Service Bulletin

NO:HIFI2-01-003

SUBJECT: Disc does not Eject

MODEL (S): MDS-JA555ES

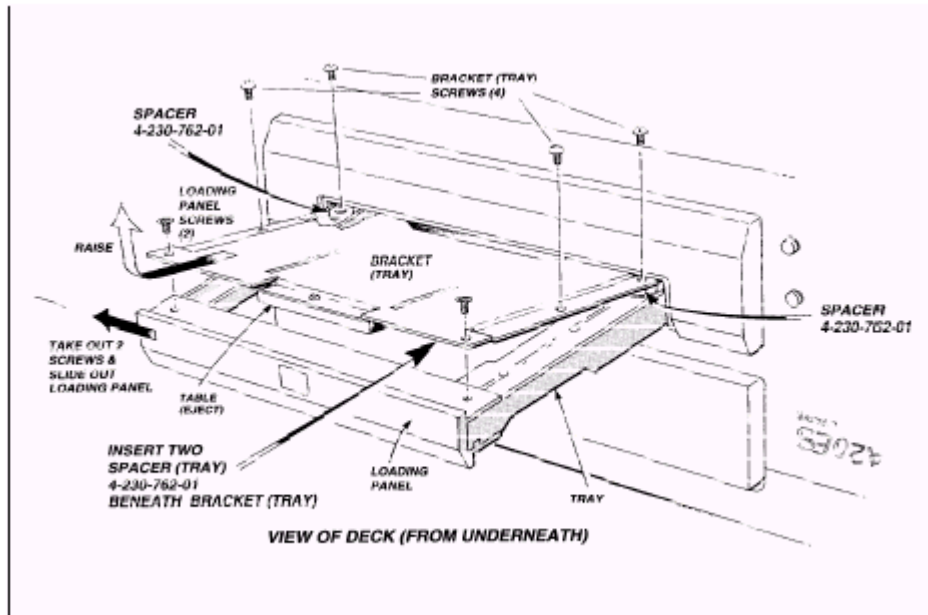
Symptom: The customer complaint states that the disc gets caught in the Tray when ejecting.

Solution: Add the SPACER (TRAY) between the BRACKET (TRAY) and TRAY.

DESCRIPTION	PART NUMBER
SPACER (TRAY)	4-230-762-01

1. Turn ON the power.
2. Open the tray and unplug the AC cord leaving the tray OPEN.
3. Turn the set upside down.
4. Remove two screws (a) from the PANEL, LOADING (b). See diagram.
5. Pull out the PANEL, LOADING (b) to the side.
6. Remove four screws (c) from the BRACKET (tray).
7. Remove the BRACKET (TRAY).
8. Attach the two SPACER (TRAY) (e) inside of the BRACKET (TRAY) (d).
9. Put back the BRACKET (TRAY) (d).
10. Put four screws (c) back on the BRACKET (TRAY).
11. Put the LOADING PANEL (b) back.
12. Put two screws (a) back on the PANEL, LOADING.
13. Turn the set over (face up).
14. Turn ON the power and make sure the unit operates correctly.
